# Access Compliance Report

## Public Rights-of-Way

| Intersection ID: 44486                  | Main Street: NEWFIELD_ST | Cross Street: DARWICK_ST                | Location: SE           |
| ADA ID: FDC3EE514DBC                    | Ramp Type: PerpDiag      | Initial Pass/Fail: Fail                 | Overall Compliance: No |

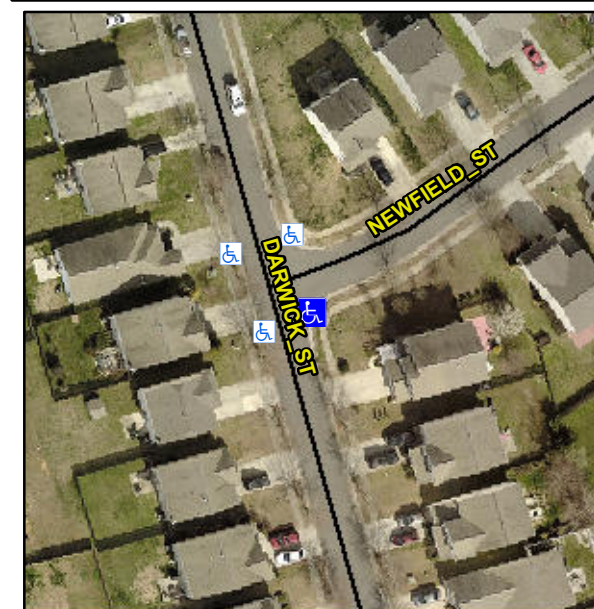
**Not Found, R304.5.1**

| Compliance | Description           | Data | Compliance | Description                 | Data |
|------------|-----------------------|------|------------|-----------------------------|------|
| No         | Ramp Width (in)       | 47.5 | Yes        | Ramp XSlope (%)             | 1.2  |

**Remove & Replace Curb Ramp With Two New Directional Ramps or Equivalent.**
